## MEMORANDUM

**Subject:** **Superposition Modeling – Summary Points**

**To:** Abby Ostovar and Derrik Williams, Montgomery & Associates  
**CC:** Nancy Isakson, Salinas Valley Water Coalition  
Eric Robinson, Kronick Moskovitz Tiedemann & Girard  
Piret Harmon and Emily Gardner, SVBGSA  
Bob Abrams, Aquilogic  
**From:** Dwight L. Smith, PG, CHg, Principal Hydrogeologist  
**Date:** October 18, 2025  
**Subject:** **Technical Review Comments on Montgomery & Associates' Superposition Modeling  
Technical Memorandum dated August 22, 2025**

**Subject: Comments on Montgomery & Associates draft Memorandum, “Results of Computer Modeling Agreement for SVWC and SBWA,” dated August 22, 2025  
Project No.: 018-09**

**FIGURE 3**

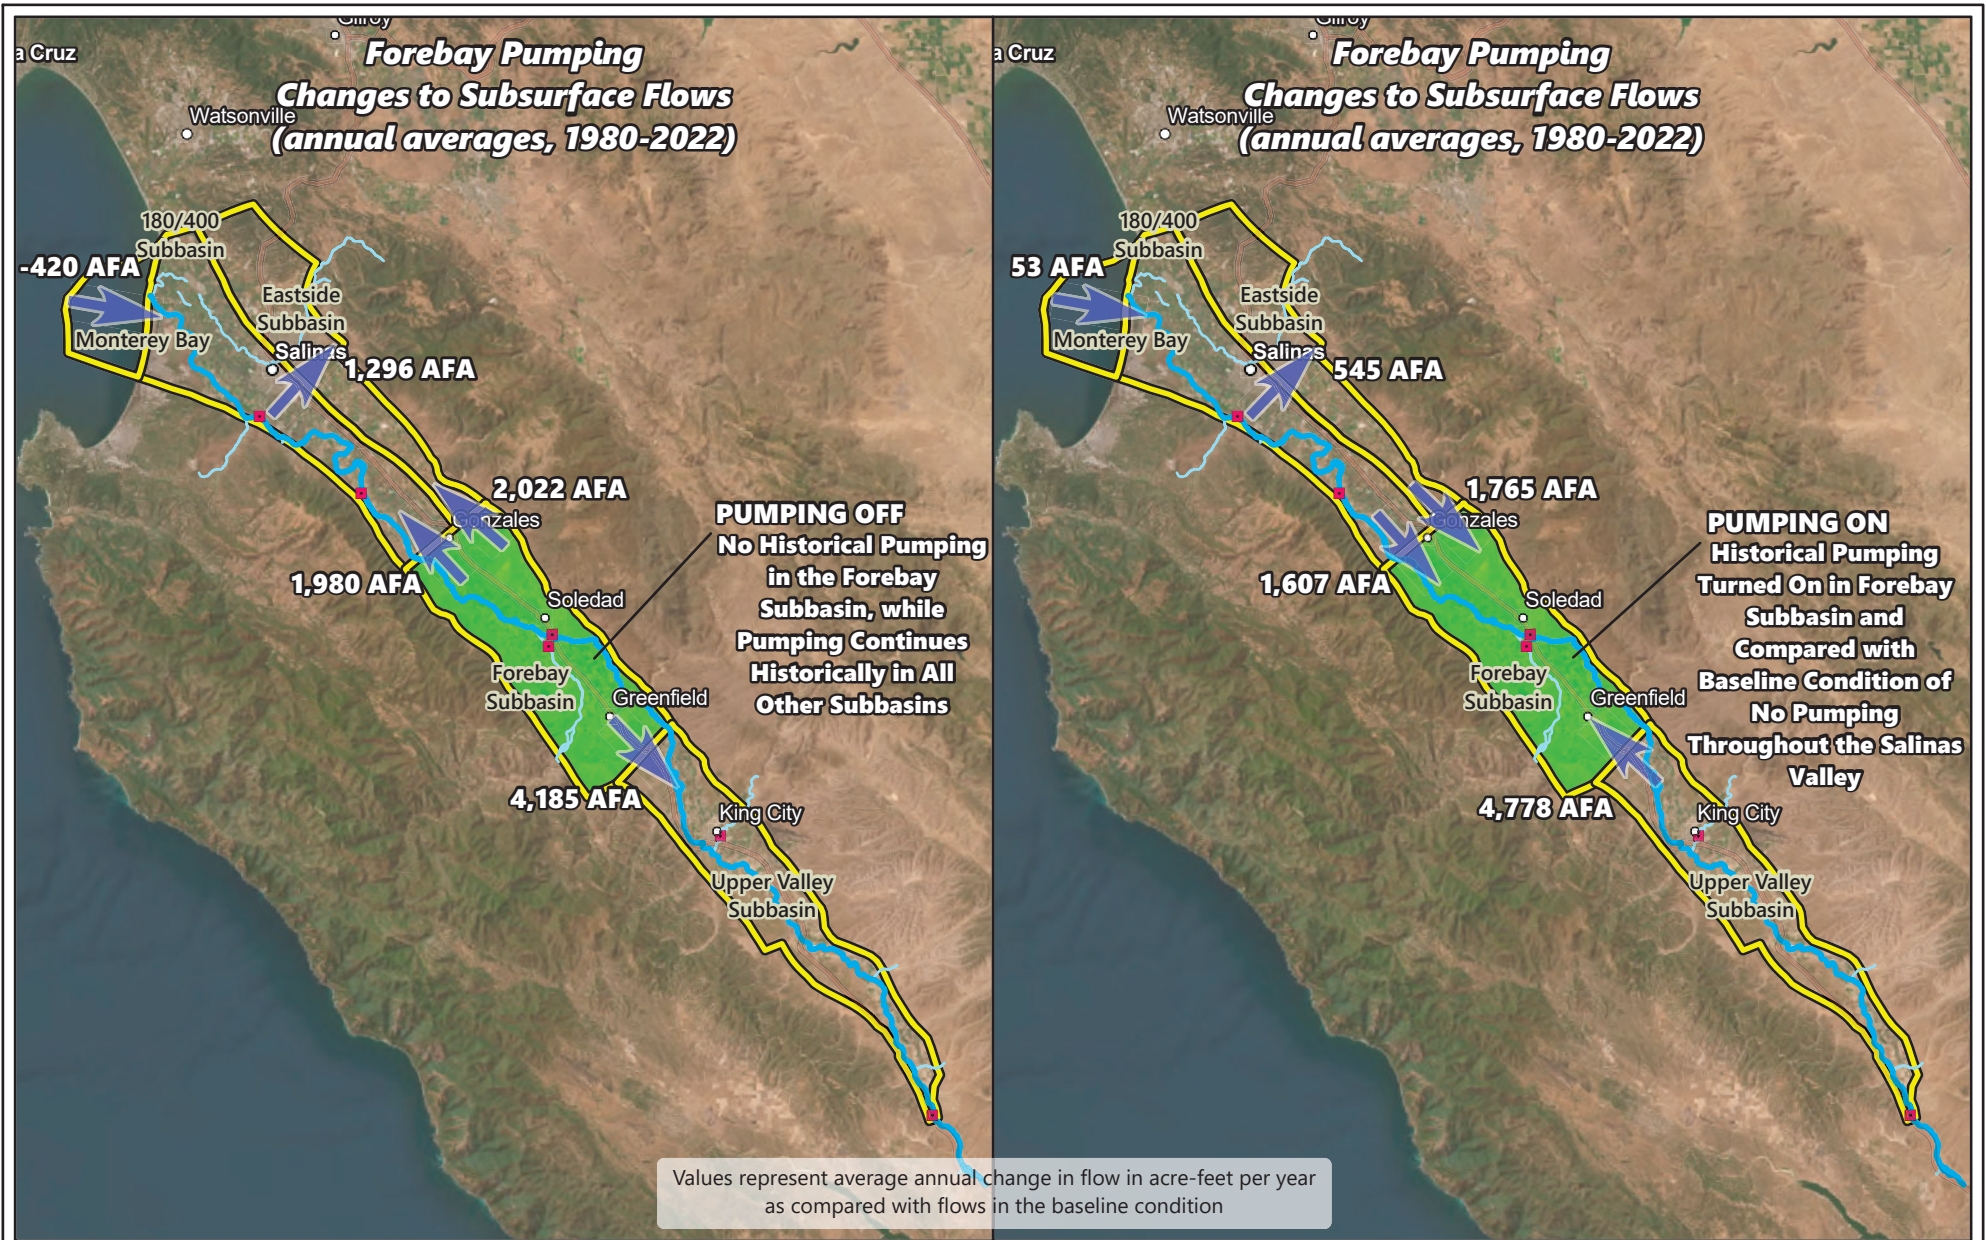
Results of the superposition testing may be made for changes to pumping in the Forebay, Eastside, and 180/400 Subbasins using Figures 3-5. Values for subsurface flows in the baseline conditions, and then the changes observed by testing pumping in each subbasin are summarized in the **Tables 1-4**. **Table 1** summarizes the superposition results from the scenario in which pumping in each subbasin is successively turned off, while pumping in all the other subbasins remains on for the hydrologic testing period 1980-2022. The first row shows the baseline amounts of annual groundwater flow between subbasins and seawater intrusion with actual historic pumping turned on in all subbasins. The second row shows the impact on inter-subbasin flows if actual historic Upper Valley pumping were turned off. For example, turning off Upper Valley pumping would reduce seawater intrusion into the 180/400 Subbasin to 8,221 AFA (down 382 AFA). Meanwhile, the bottom row shows that turning off 180/400 Subbasin pumping would reduce seawater intrusion into the 180/400 Subbasin to 456 AFA (down 8,147 AFA). Those and all the other net changes in inter-subbasin flows and seawater intrusion are summarized below in **Table 2**.

**FIGURE 6**  
 Historical & Aquifer Full Baseline Maps  
 Superposition Model Testing

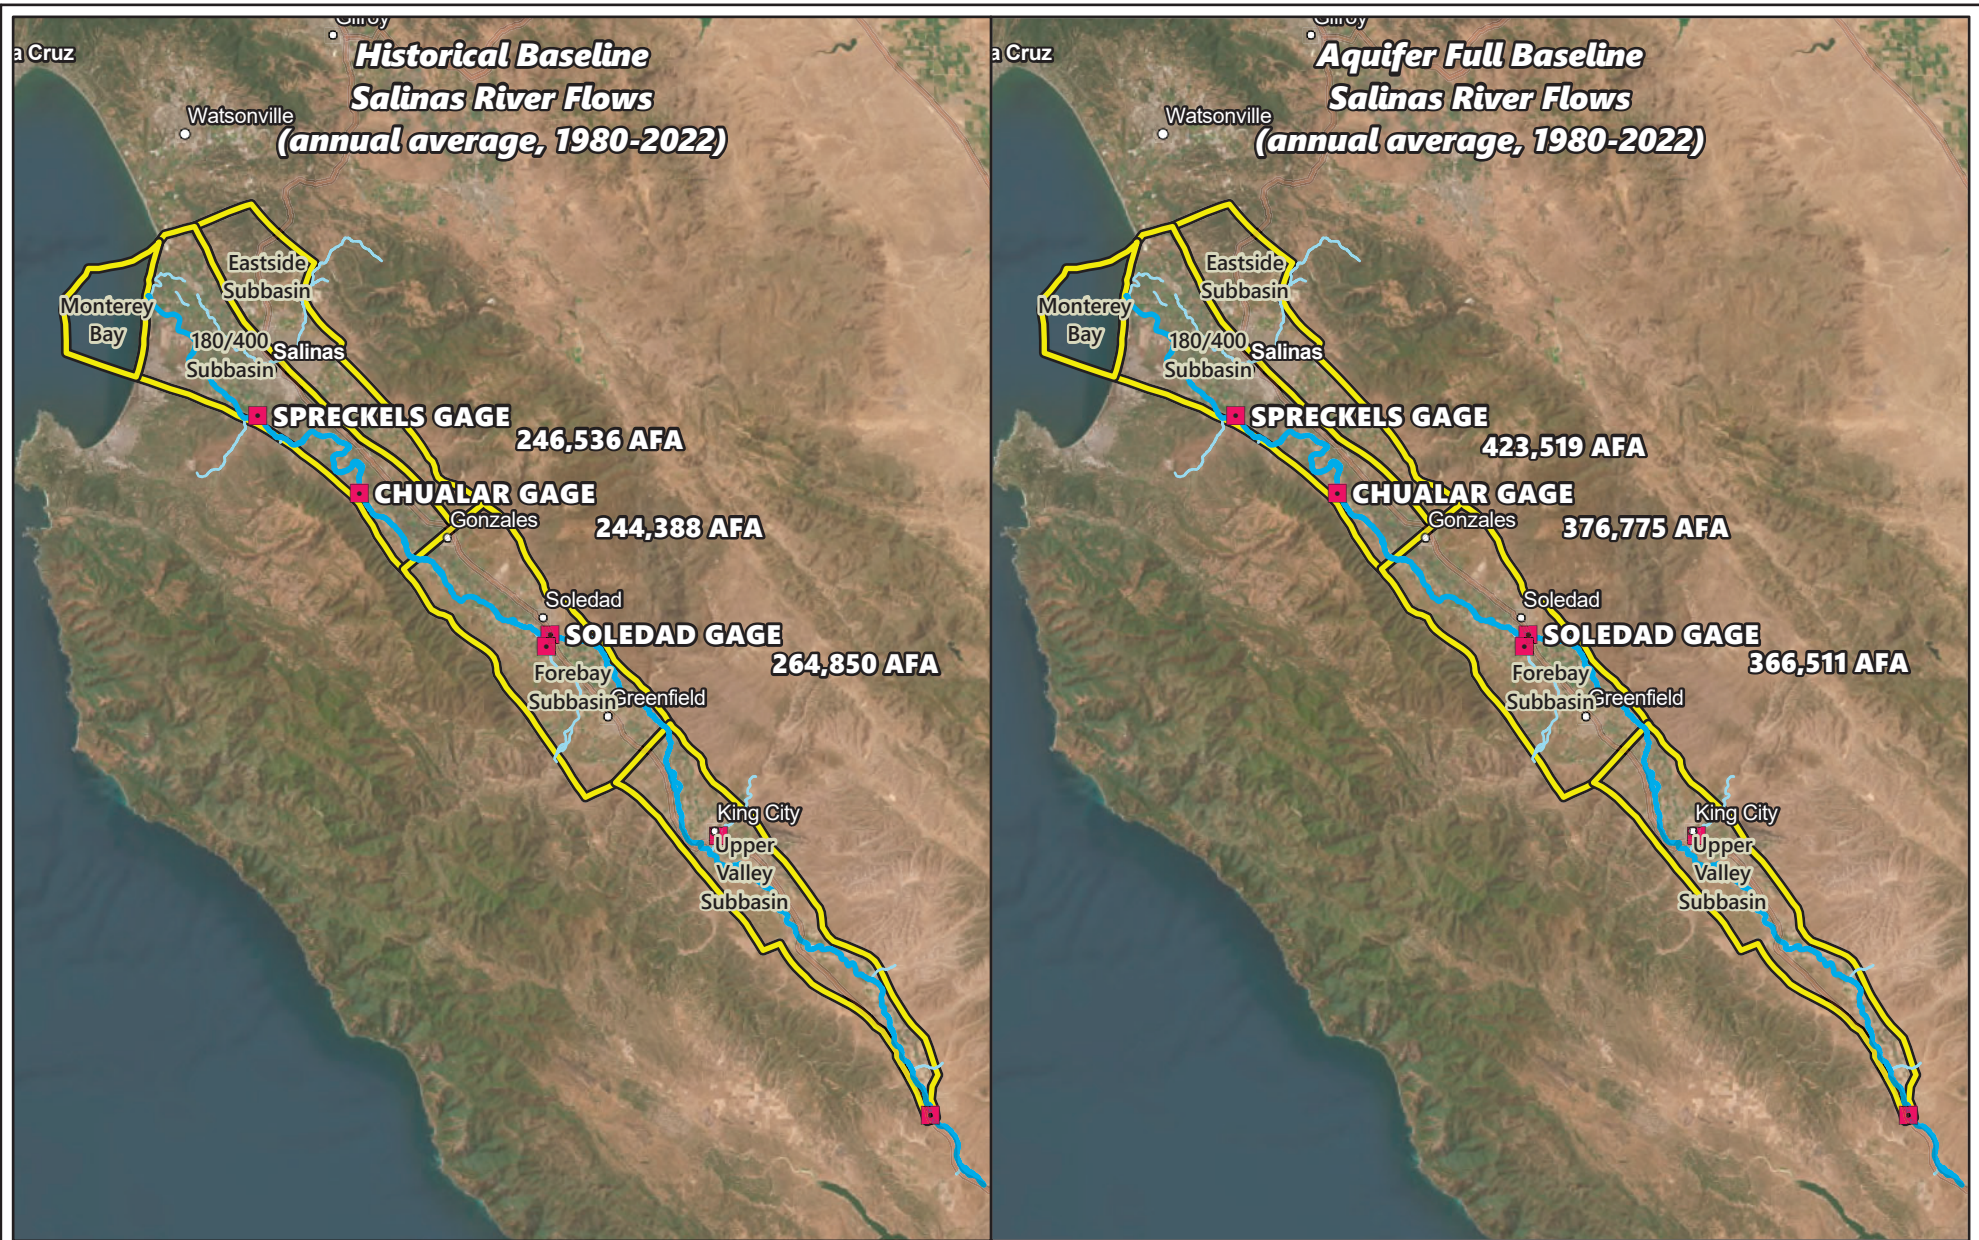
For example, Salinas River average annual flow at the Spreckels gage for historical pumping baseline is simulated at 246,536 AFA (left pane, **Figure 6**). When all historical pumping in the Upper Valley Subbasin is turn off for the simulation period, there is an increase in average annual flow at the Spreckels gage of 35,904 AFA (left pane, **Figure 7**), or an approximate flow increase of 14.6% (**Table 5**). For the “full aquifer” baseline conditions, historical pumping turned on in the Upper Valley Subbasin is simulated to decrease the average annual flow at the Spreckels gage from 423,519 AFA to 378,498 AFA, or a reduction in flow of 45,020 AFA or 10.6% of the total annual flow at Spreckels (refer to **Figure 7** right pane, and **Table 6**).

Figure 1

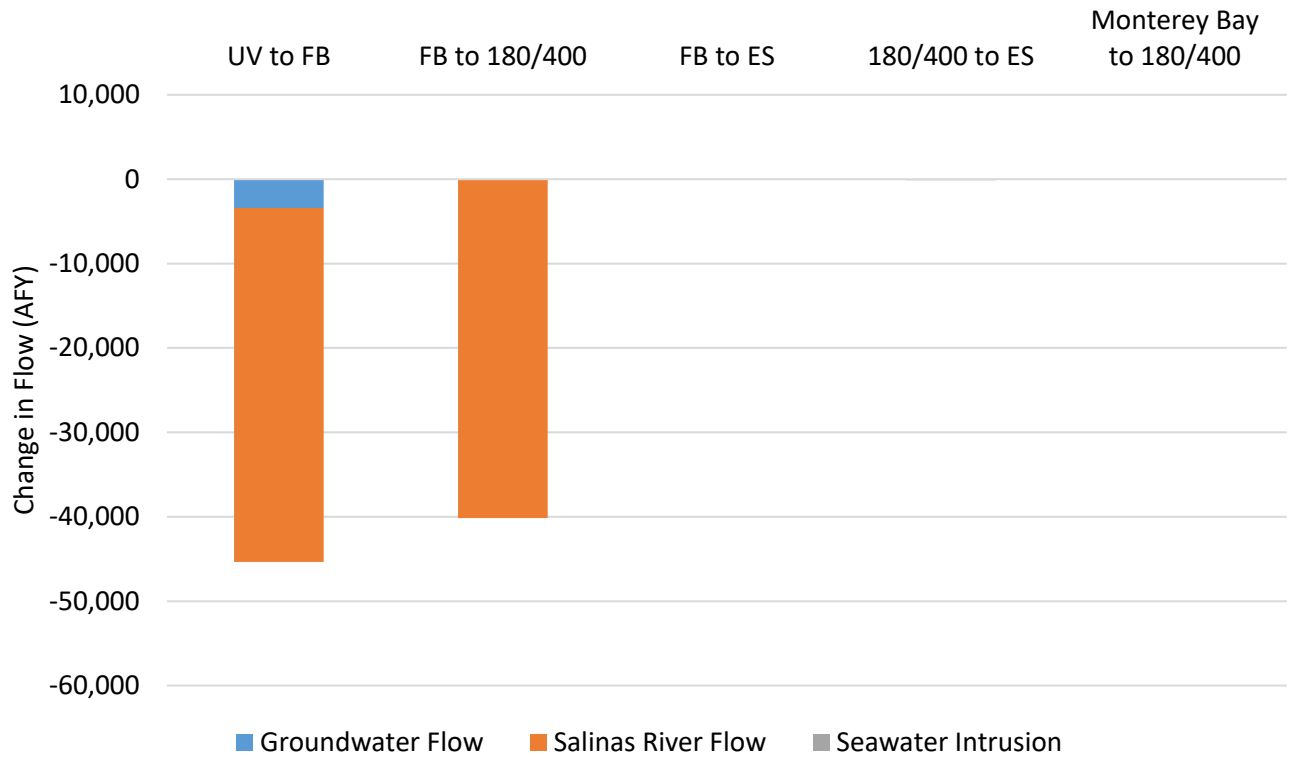
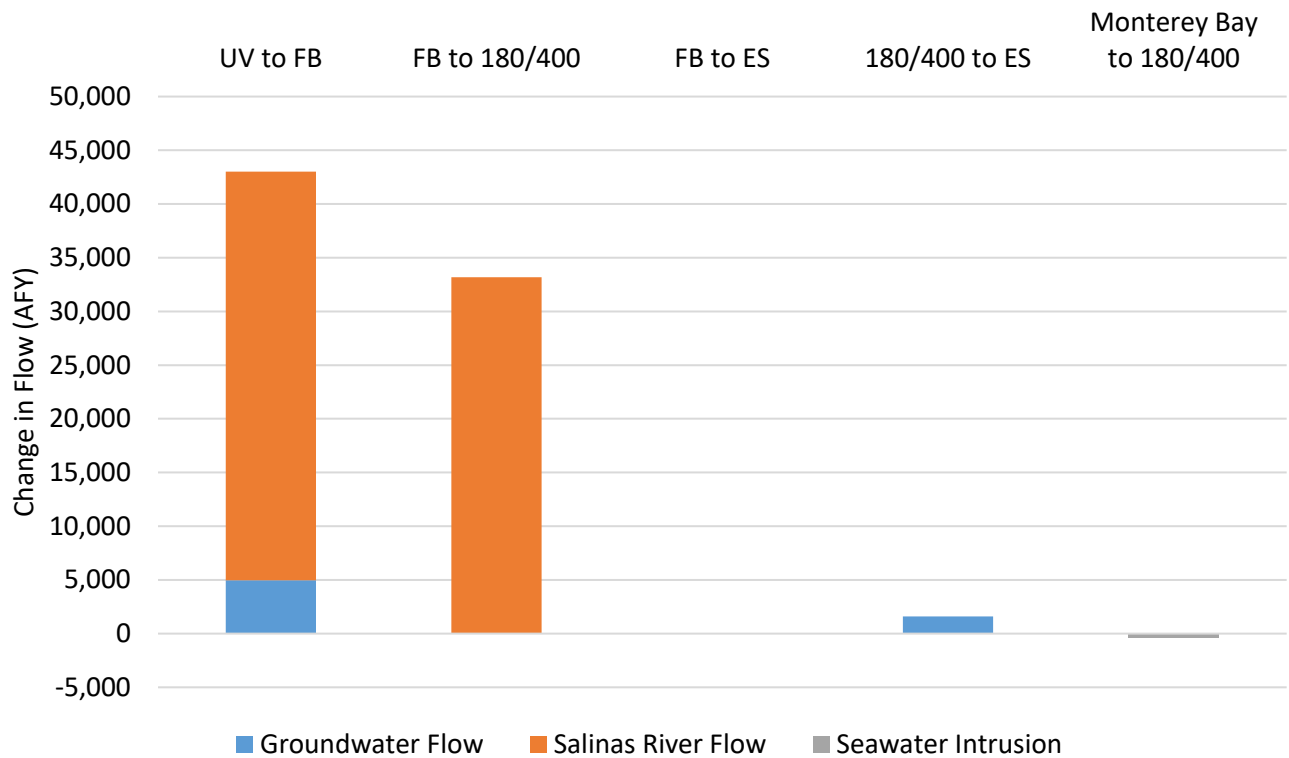
**Aquilologic Figure 1** shows the changes in Salinas River stream flows and groundwater flow between subbasins caused by pumping in the UV. **Aquilologic Figure 2** shows the changes in Salinas River stream flows and groundwater flow between the subbasins caused by pumping in the FB. **Aquilologic Figure 3** shows the changes in Salinas River stream flows and groundwater flow between the subbasins caused by pumping in the 180/400. **Aquilologic Figure 4** shows the changes in Salinas River stream flows and groundwater flow between the subbasins caused by pumping in the ES. All four figures also show the impact on seawater intrusion (SWI) caused by pumping in each subbasin.

1. Changes in Salinas River stream flows are significantly larger than changes in groundwater flow between the UV, FB, and 180/400:
  - a. Pumping in the UV removes approximately 40,000 acre-feet per year (AFY) from the Salinas River (predominantly growing season reservoir releases), **reducing water availability and groundwater replenishment in the FB and 180/400** (compared to 105,370 AFY total UV groundwater pumping<sup>5</sup>)
    - i. Therefore, approximately 38% of the pumping in the UV is derived directly from the Salinas River (i.e., growing season reservoir releases)

Figure 2

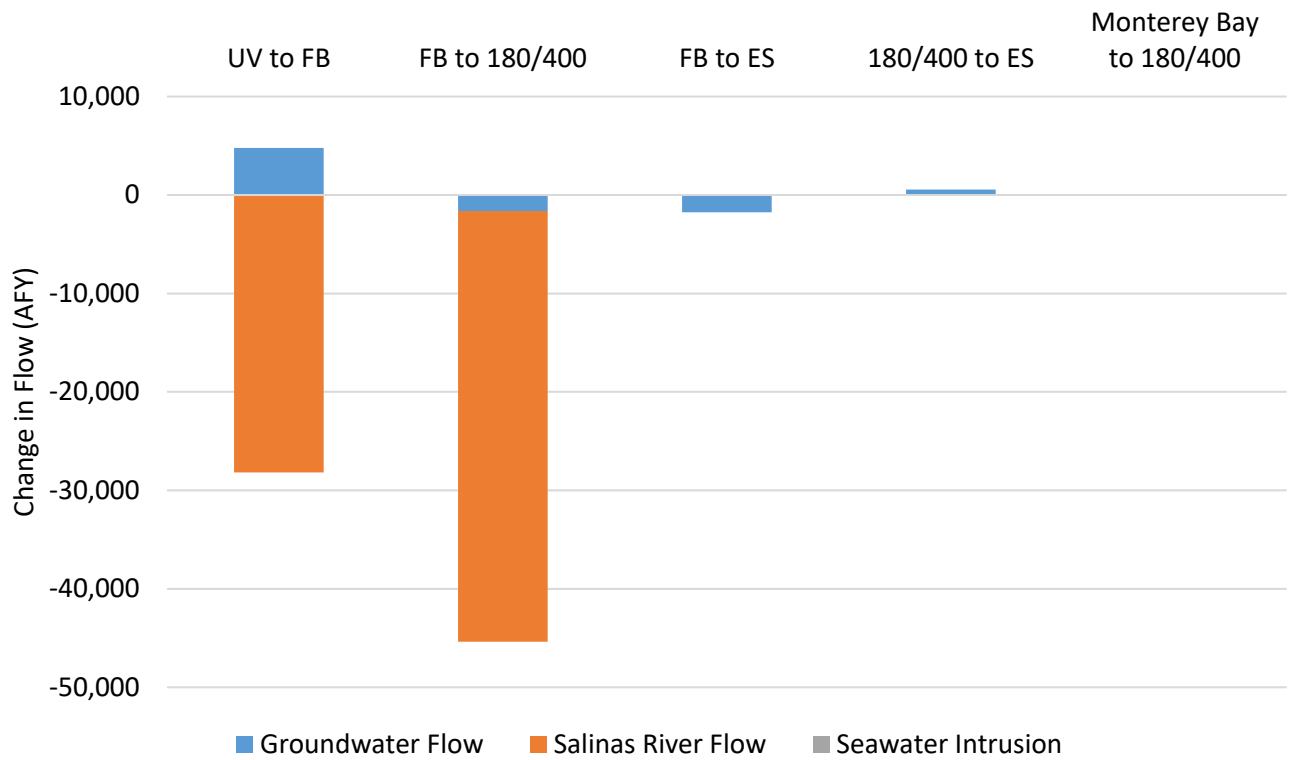
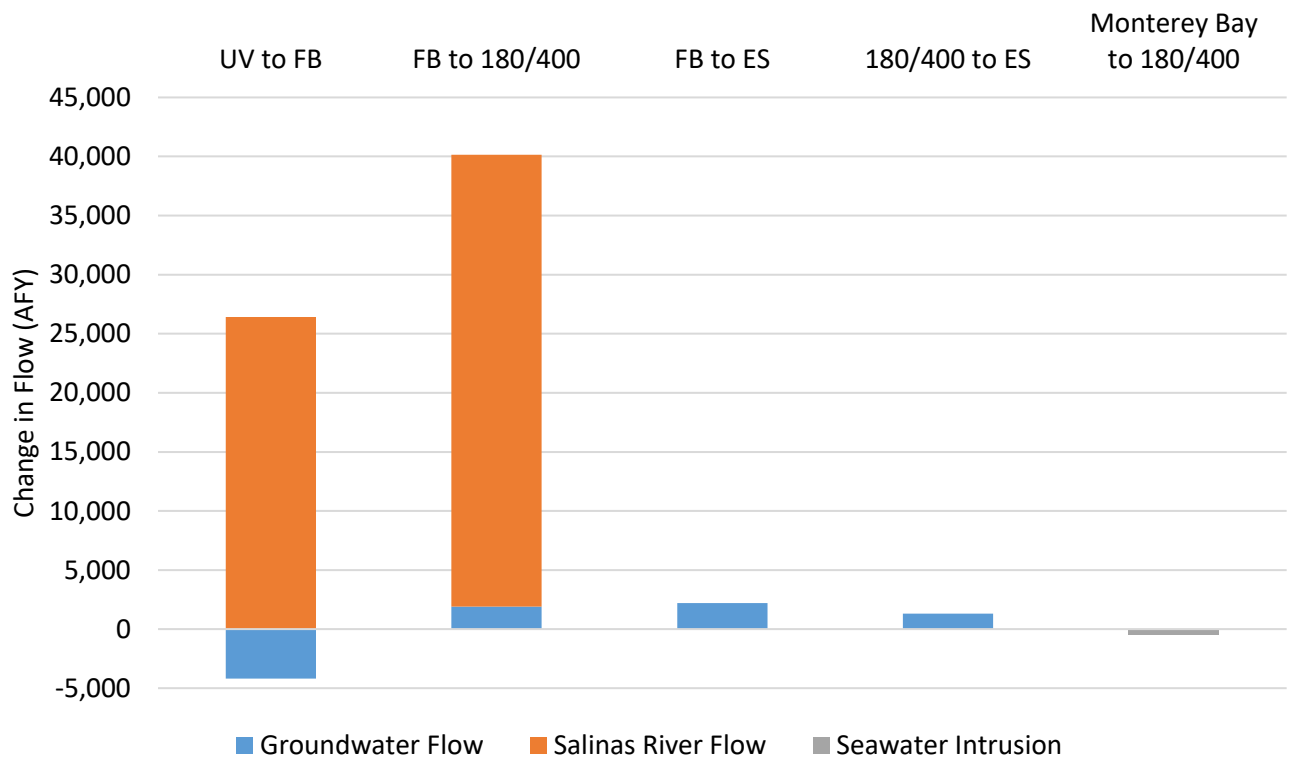
- b. Pumping in the FB removes approximately 40,000 AFY from the Salinas River (predominantly growing season reservoir releases), reducing water availability in the 180/400 (compared to 118,320 AFY total FB groundwater pumping<sup>6</sup>)

- i. Therefore, approximately 35% of the pumping in the FB is derived directly from the Salinas River (i.e., growing season reservoir releases), potentially with contributions from the Arroyo Seco early in the growing season
